**Response to the
September 4, 2018 MDEP / LUPC Information
Request**

New England Clean Energy Connect (NECEC)

Prepared for:
**Maine Department of Environmental Protection
and Maine Land Use Planning Commission**

October 19, 2018

Figure 2, below, depicts the wire zone for a typical single pole structure associated with the HVDC transmission line.

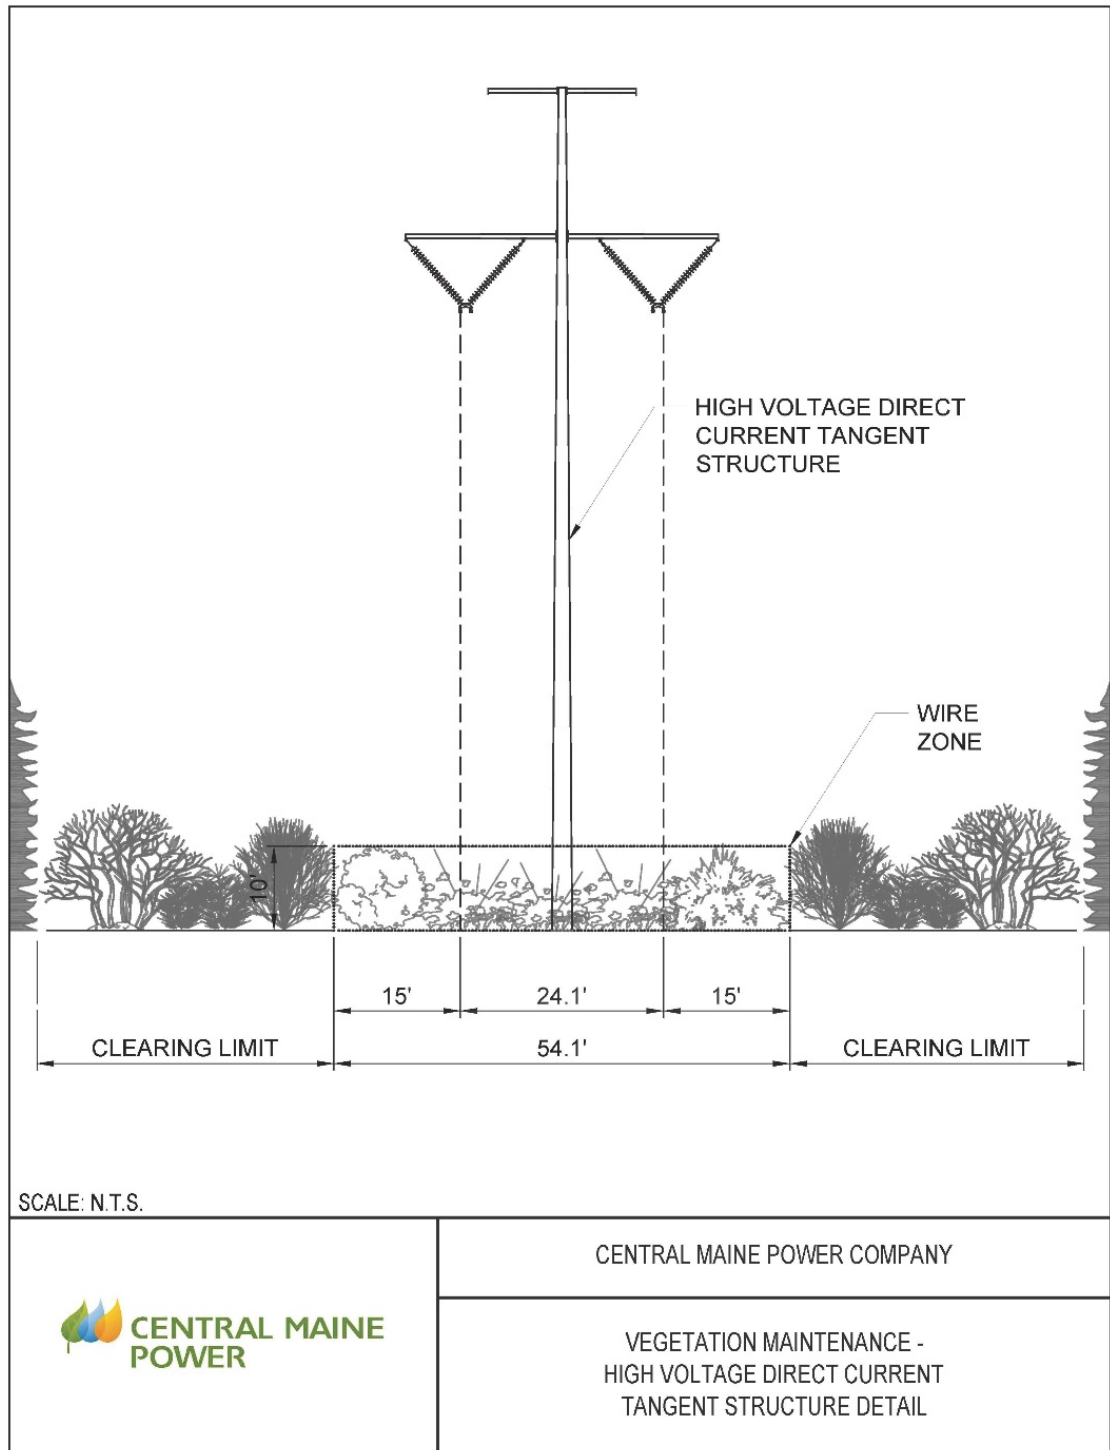
- 7. In response to Question 15 concerning the VCP around streams, you state that within the "wire zone" all woody vegetation will be cut. This statement is repeated in the complete revised VCP (August 14 submission Attachment B) but goes on to add that non-capable species would be allowed to remain if they won't pose a hazard. Please provide a list of non-capable species. How are non-capable species identified? Also in regard to the VCP and the VMP both contain your typical diagram of an H-Frame structure which shows the wire zone. However, a majority of the HVDC line will be on single pole structures. Can you please provide a diagram to be included with these vegetation management plans that shows the wire zone for a single pole structure? This detail should be included in the VMP and the VCP.**

CMP's standard practice, within the portion of the stream buffer *within the wire zone* (i.e., within 15 feet, horizontally, of any conductor), is to cut all woody vegetation *over 10 feet in height* to ground level with the resulting slash managed in accordance with Maine's Slash Law. No other vegetation, other than dead or hazard trees, will be removed. Within the stream buffer and *outside of the wire zone (i.e., within the border zone)*, non-capable species (also referred to as "compatible" species) will be allowed to

exceed 10 feet in height unless it is determined that they may encroach into the conductor safety zone prior to the next four-year maintenance cycle.

Determining whether a species is compatible considers several factors. The primary consideration is the height of the plant at maturity. Species that have the potential to grow into the Minimum Vegetation Clearance Distances (MVCD) are deemed to be capable or incompatible and are targeted for removal from the right-of-way. Another consideration is typical vegetation growth rates in Maine to account for growth between the four-year maintenance cycle to insure adequate clearance for public safety and reliability of the lines. The allowable vegetation heights are based on the minimum ground to conductor clearance at maximum conductor sag.
